The Sandstone Precinct

Heritage Conditions

Date
24 September 2017

Revision Number
02

EB: Farrer Place/G level

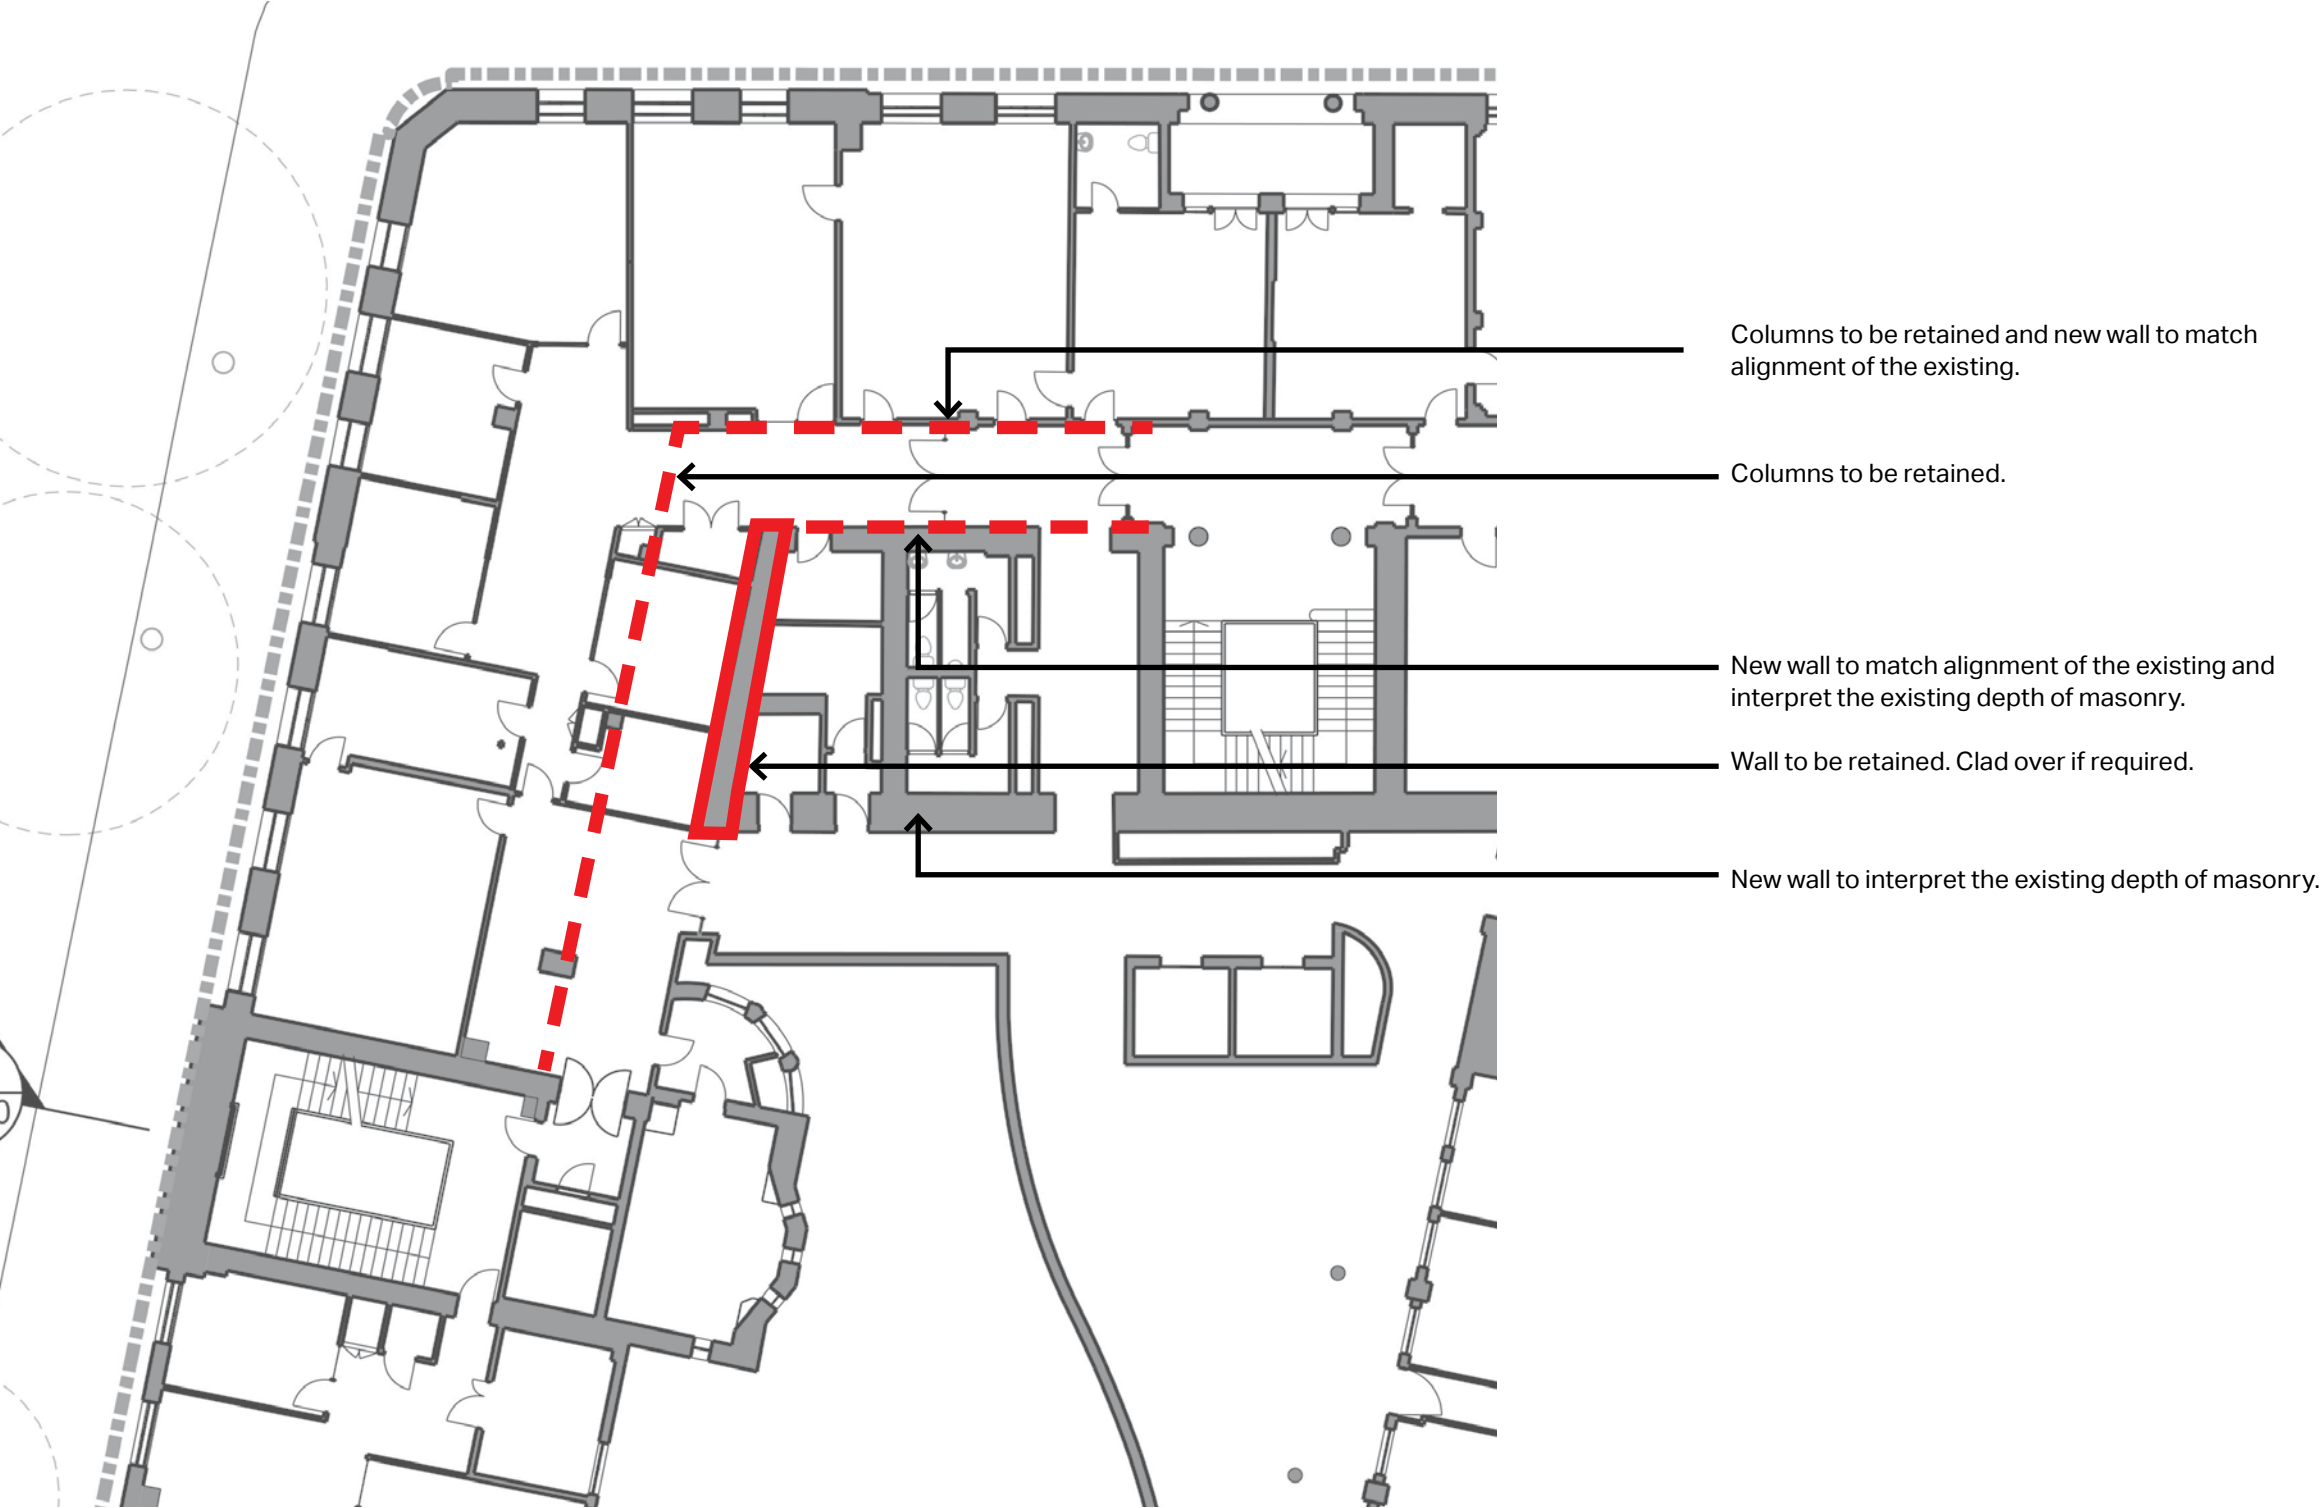
Columns to be retained and new wall to match alignment of the existing.

Columns to be retained.

EB: Farrer Place/G level

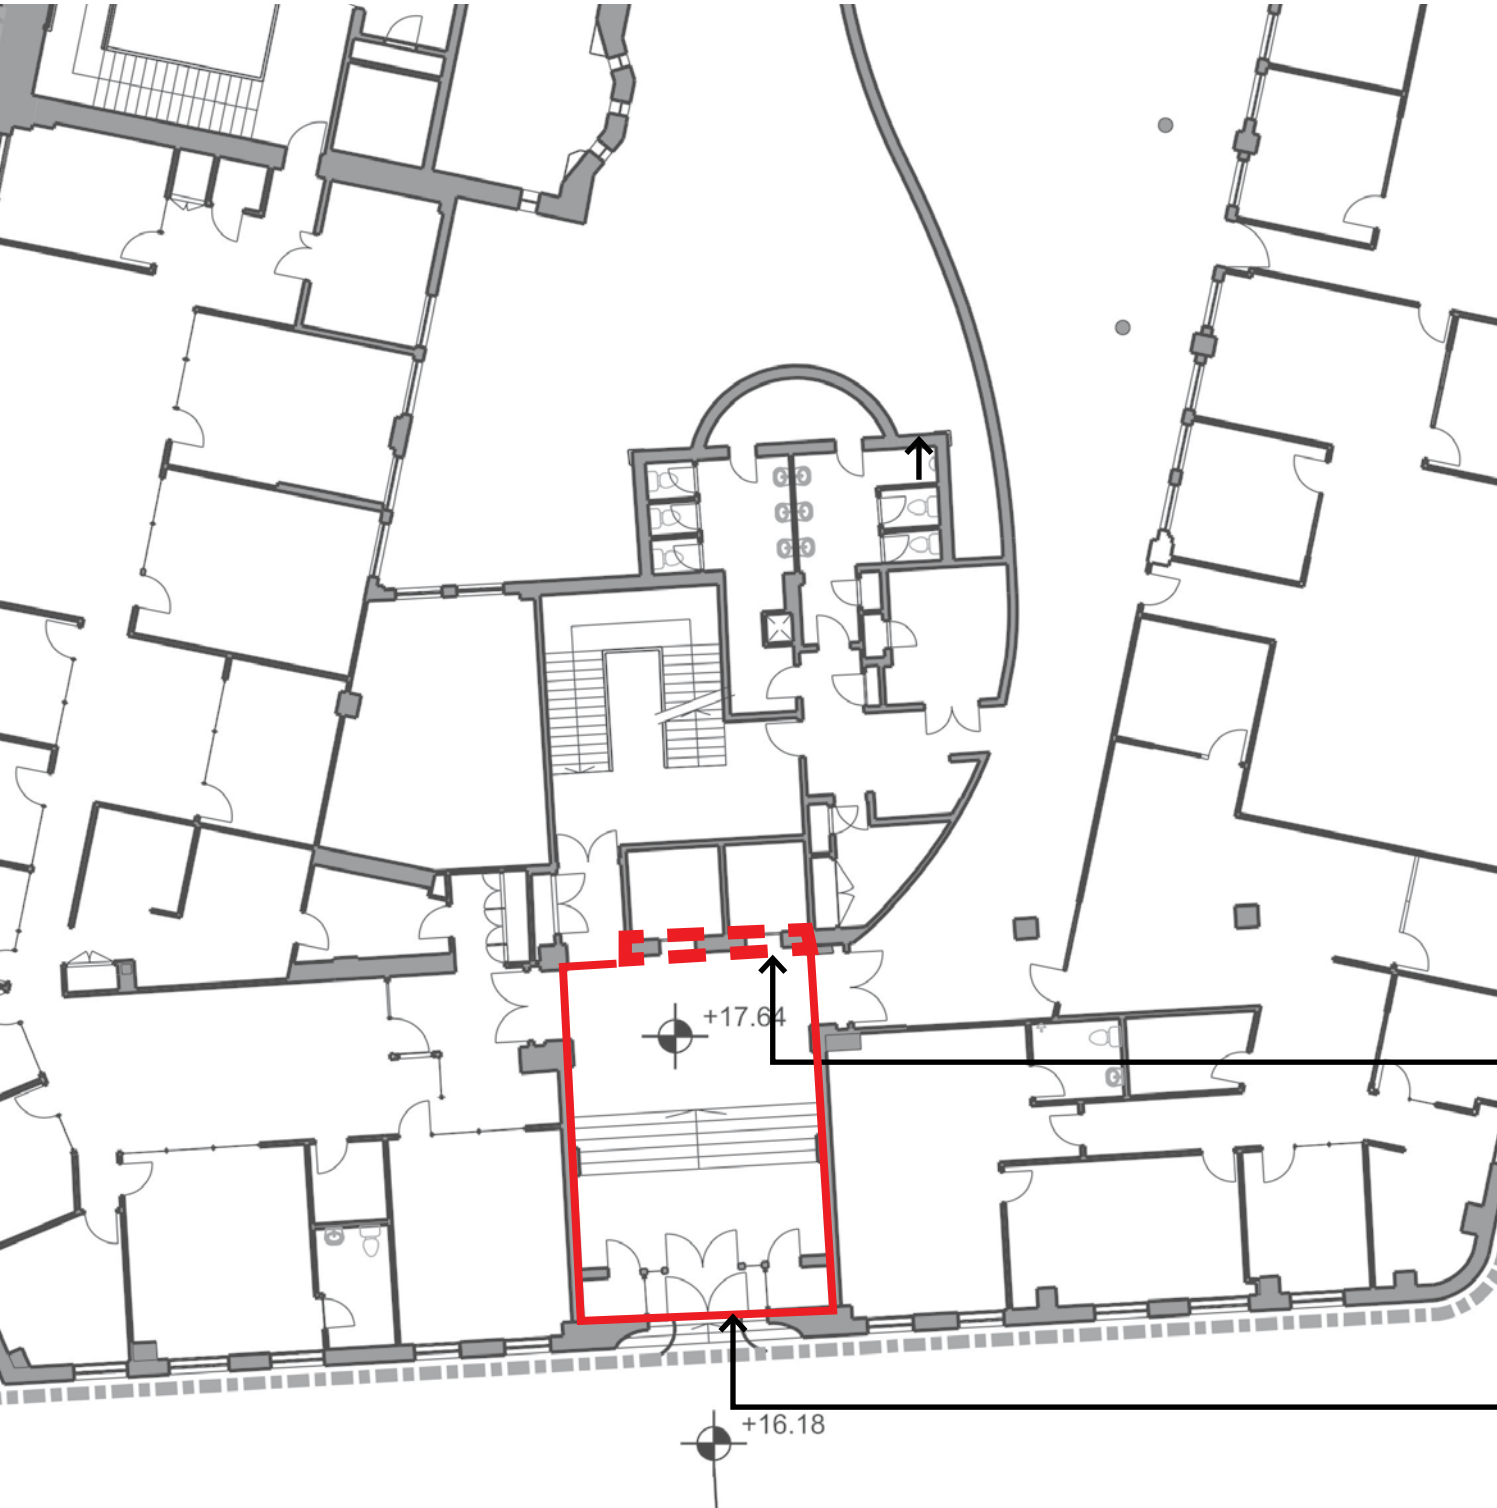
New wall to match alignment of the existing and interpret the existing depth of masonry.

Wall to be retained. Clad over if required.

New wall to interpret the existing depth of masonry.

- Existing lift surround removed to enable clear access to the central sculpture courtyard. Marble and trachyte to be salvage and reused for on site repair works.
- Floor and ceiling to be clearly delineated between existing and new. Bulkhead element to be maintained.
- Last row of columns to be read in order to terminate the vestibule as a 'room'.

EB: Farrer Place/G level

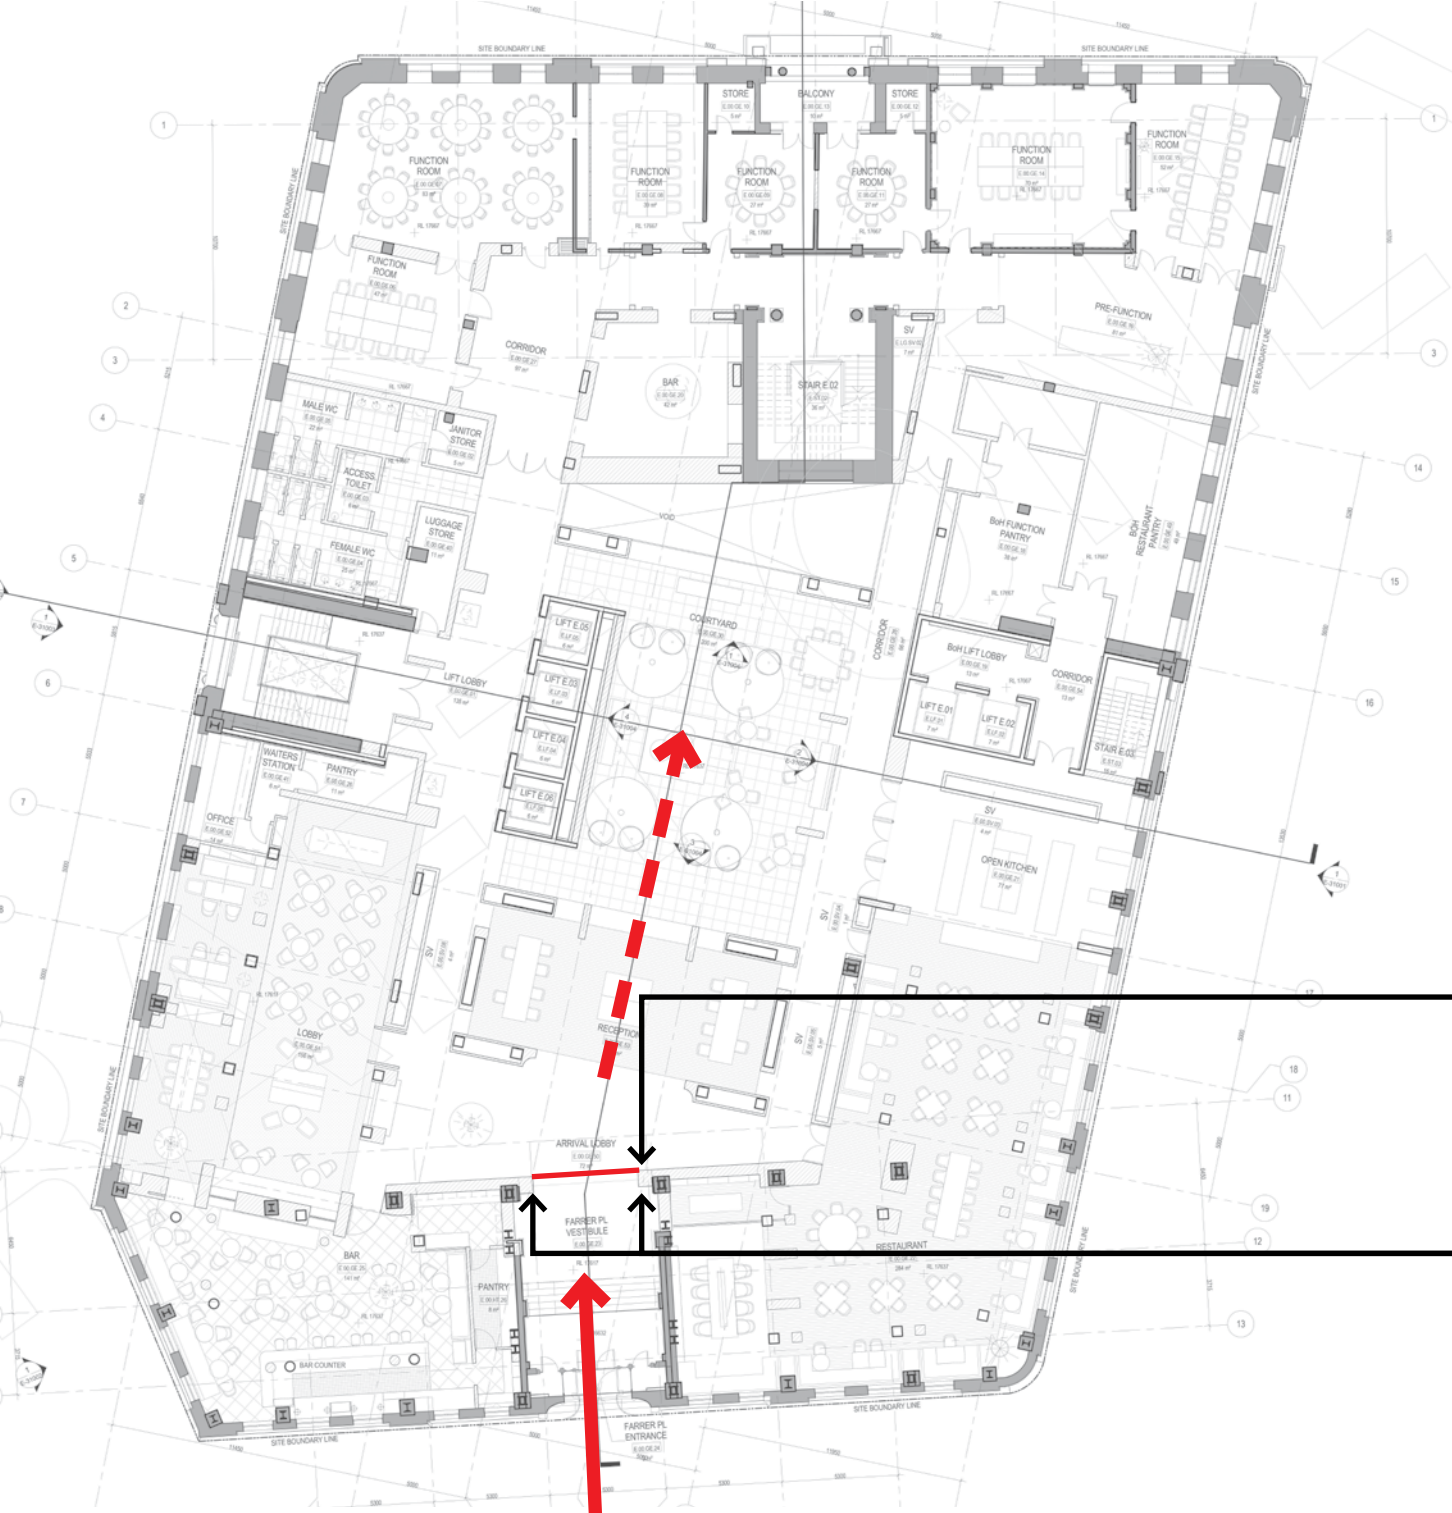
All other original elements of the vestibule to be retained

Materiality of infill to be investigated and details shown of the interface to the existing columns in order to minimise interventions.

Change in floor finish clearly marked to delineate the heritage vestibule from the new reception area.

Existing columns to be 'completed' in order to terminate the vestibule. The 'completed' column element should draw on the existing form and proportions but not seek to imitate. The design to investigate a material that does not attempt to perfectly match the existing but is complementary, e.g. scagliola with an appropriate pigment. Avoid the use of nibs as currently shown.
